TRANS/WP.29/GRRF/2000/19  
28 June 2000

World Forum for Harmonization of Vehicle Regulations (WP.29)

Working Party on Brakes and Running Gear (GRRF)  
(Forty-eighth session, 11-13 September 2000,  
agenda item 2.)

PROPOSAL FOR DRAFT AMENDMENTS TO THE DRAFT REGULATION  
ON UNIFORM PROVISIONS CONCERNING THE APPROVAL OF TANK VEHICLES  
OF CATEGORIES N AND O WITH REGARD TO ROLLOVER STABILITY

Figure 1: Steering wheel angle and true sine error band

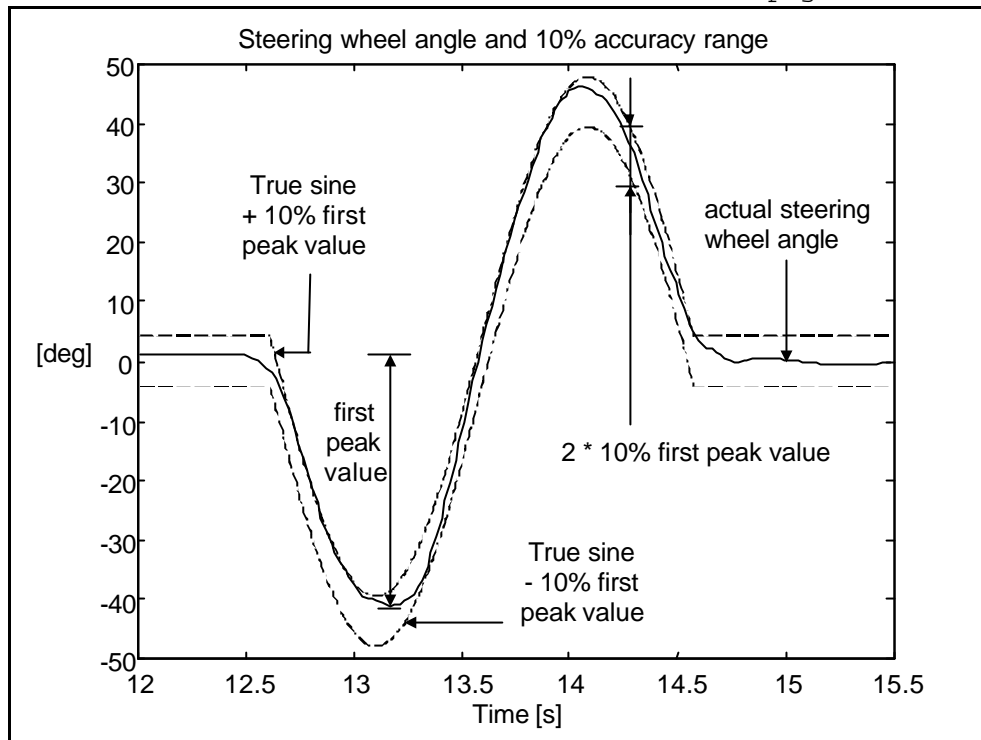
The vehicle shall be driven at a constant speed of 80 km/h or at the maximum design speed if this is less than 80 km/h. The tolerance for the speed is  $\pm 2$  km/h. Starting with straight line driving at the test speed, one full period sinusoidal steering-wheel input shall be applied with a steering frequency in the range of 0,2 Hz to 2,0 Hz. The amplitude error of the actual waveform compared to the true sine wave shall be within 10 per cent of the first peak value (see Figure 1).

Figure 2: Peak values of lateral acceleration ( $A_y$ ) and body roll angle (Roll). The ratio is the peak Roll divided by the peak  $A_y$ .

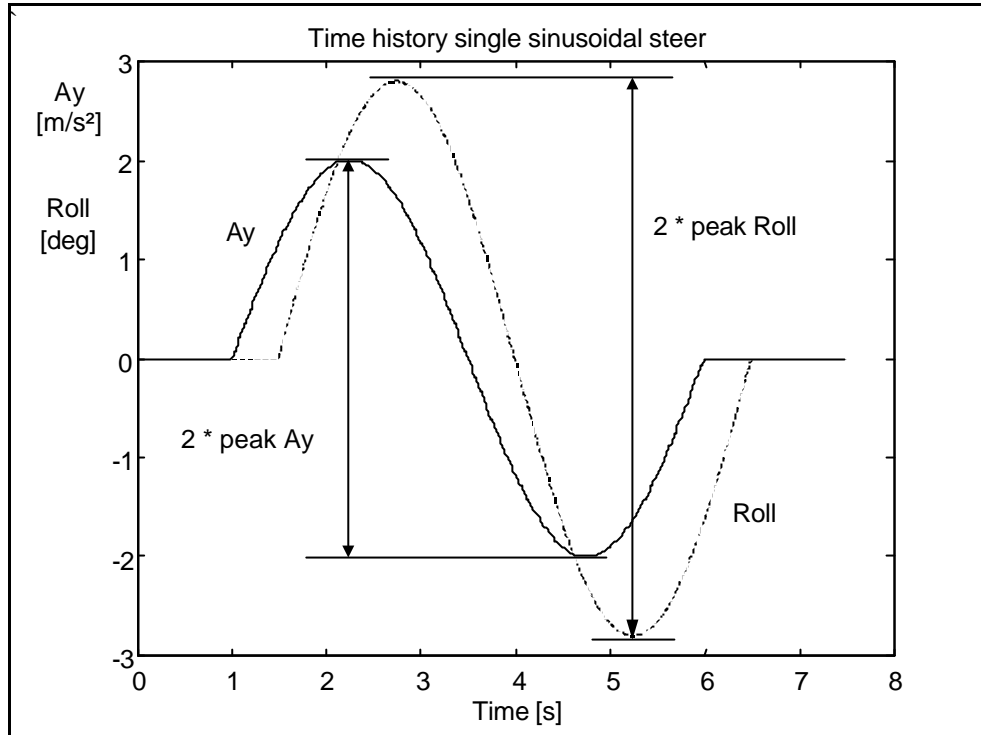
The characteristic value to be determined by this preliminary test is the maximum value of the ratio of the peak roll angle to the peak lateral acceleration (see Figure 2). The frequency value at which this occurs shall then be used in the single sinusoidal steer input test (see paragraph 6.2 below).
